Access Compliance Report

Public Rights-of-Way

Intersection ID: 2719	Main Street: BEAUVISTA_DR	Cross Street: HIGHLAND_CREEK_PY	Location: SE
ADA ID: 865D88757461	Ramp Type: PerpDiag	Initial Pass/Fail: Fail	Overall Compliance: No
Severity Score: 25			
Codes/Mitigation Info/Possible Solution		Field Measurements/Component Compliance

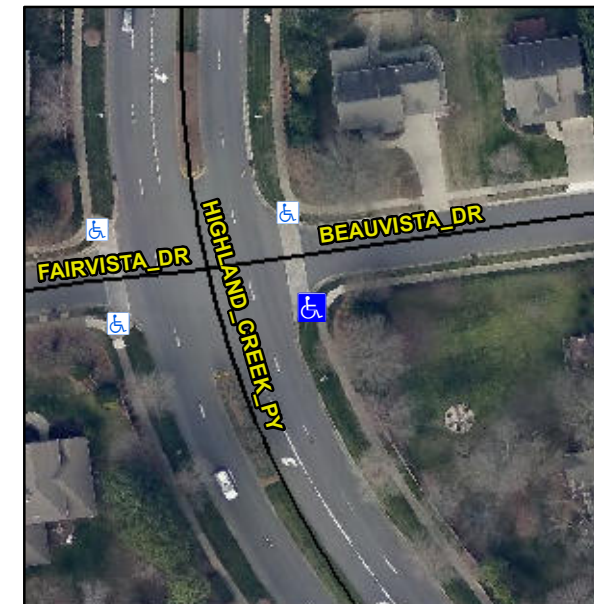
Not Found, R304.5.3

Compliance	Description	Data	Compliance	Description	Data
N/A	Ramp Length (in)	71.5	Yes	Ramp Slope (%)	7.4
Yes	Ramp Width (in)	48.0	No	Ramp XSlope (%)	8.3
N/A	Flare Type LT	N/A	N/A	Flare Type RT	N/A
N/A	Flare Slope LT (%)	N/A	N/A	Flare Slope RT (%)	N/A
N/A	Flare Traversable LT?	N/A	N/A	Flare Traversable RT?	N/A
N/A	Landing Length (in)	N/A	N/A	DWS Provided?	N/A
N/A	Landing Width (in)	N/A	N/A	DWS Contrast?	N/A
N/A	Landing Slope (%)	N/A	N/A	DWS Length (in)	N/A
N/A	Landing X Slope (%)	N/A	N/A	DWS Full Width?	N/A
N/A	Landing Curb? (Y/N)	N/A	N/A	DWS Offset (in)	N/A
N/A	Shared Landing?	N/A			
N/A	Gutter Ponding?	N/A	N/A	Gutter Slope (%)	N/A
N/A	Gutter Lip Ht (in)	N/A	N/A	Gutter X Slope (%)	N/A
N/A	Painted X Walk1?	No	N/A	Painted X Walk2?	No
	X Walk 1 Direction	To N		X Walk 2 Direction	To W
N/A	X Walk 1 Width (in)	N/A	N/A	X Walk 2 Width (in)	N/A
	X Walk 1 Slope (%)	2.3		X Walk 2 Slope (%)	4.9
	X Walk 1 X Slope (%)	0.6		X Walk 2 X Slope (%)	3.2

Remove & Replace Curb Ramp With Two New Directional Ramps or Equivalent.
